**ACCESSIBILITY REPORT
DEVELOPMENT APPLICATION**

23rd July 2024

**WARRIEWOOD NURSERY
10-12 BOONDAH ROAD, WARRIEWOOD, NSW 2102**

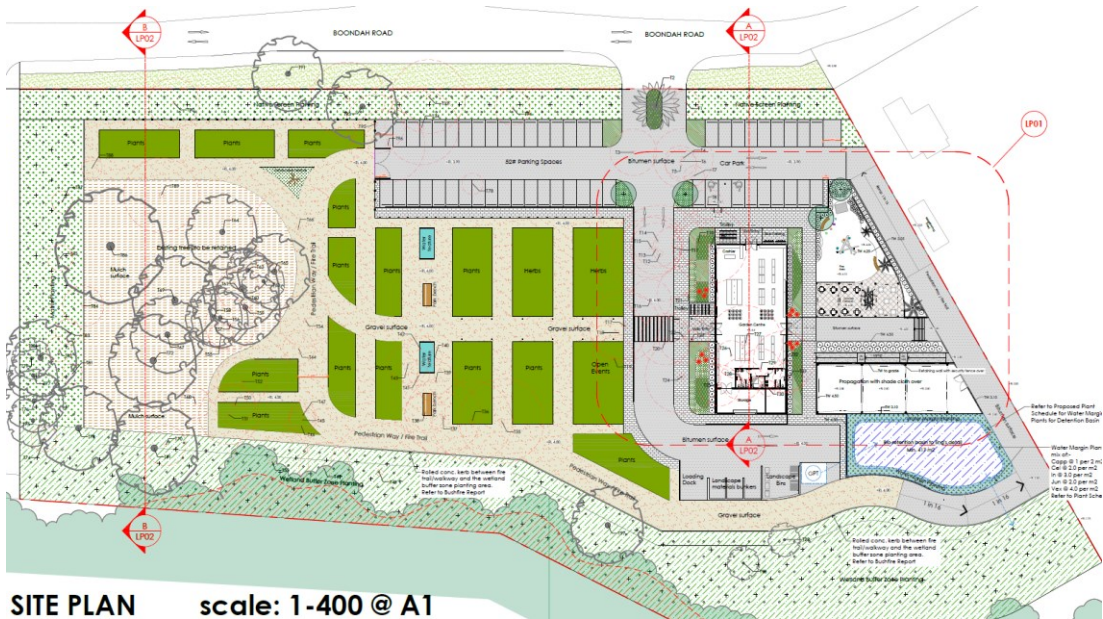
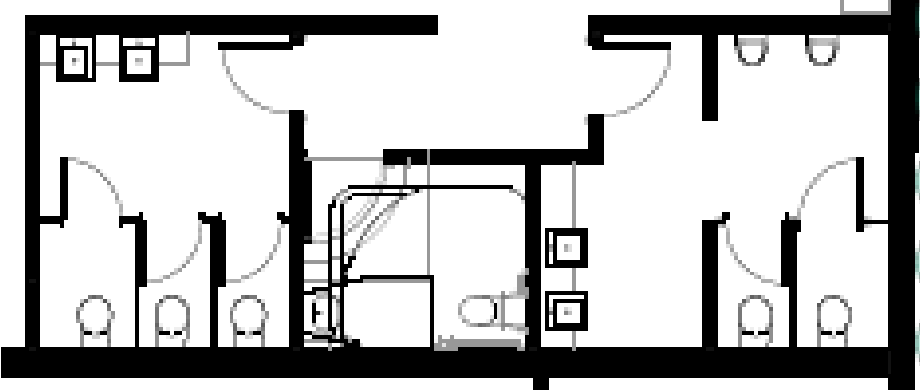
2.	<p>Site Access</p> <p>The development proposes an approximate 1:10 sloping entry driveway from RL2.60 on Boondah Road to the carpark level @RL3.90. While the plans do not show a pedestrian access ramp to enter the site it is evident a 1:14 maximum gradient pedestrian ramp can be constructed in accordance with AS1428.1 to satisfy clauses D4D1, D4D2, D4D3 of the NCC.</p>	Can Comply

Building Element	Compliance
3.	<p>Parking</p> <p>The onsite parking includes two accessible parking spaces that propose a 2400mm width space adjoining a 2400mm width Shared Area in accordance with AS2890.6 to satisfy clause D4D6 of the NCC.</p> <p>There will be at least 2500mm overhead clearance above the accessible parking and have a 1:40 slope and level crossfall on a bitumen surface with a bollard and signage in accordance with AS2890.6 to satisfy clause D4D6 of the NCC.</p>	Complies

4.	<p>The plans show a kerb ramp adjoining the shared area of the accessible parking which can be detailed at a future stage to achieve a 1:8 gradient in accordance with AS2890.6 to satisfy clause D4D6 of the NCC.</p> 	Can Comply

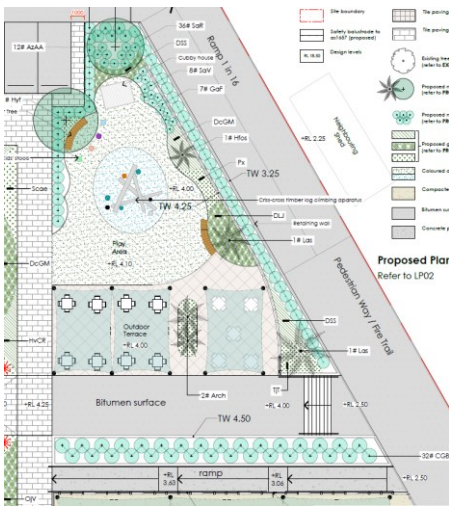
5.	 <p>SITE PLAN scale: 1-400 @ A1</p>	
6.	<p>Garden Centre Shop outdoor accessways a perimeter path @RL4.15 to RL4.25 with 1:20 gradient ramps to enter the building @RL4.40 and while 1:20 sloping doorway landings exceed the maximum 1:40 it is apparent that minor adjustments to pathway levels can enable accessible building entrances as required by AS1428.1 to satisfy clauses D4D2, D4D3 of the NCC.</p> <p>The double doorways propose ample doorway circulation spaces and can be modified to provide level 1450mm minimum length lands with a level threshold and 920mm minimum doors to ensure a 850mm minimum clear opening as required by AS1428.1 to satisfy clauses D4D2, D4D3 of the NCC.</p>	<p>Can Comply</p> <p>Can Comply</p>

Building Element	Compliance
	Other details of D-Lever door handles, force to open the doors, door luminance contrast and glazing markings (where required) shall be confirmed at construction documentation phase.
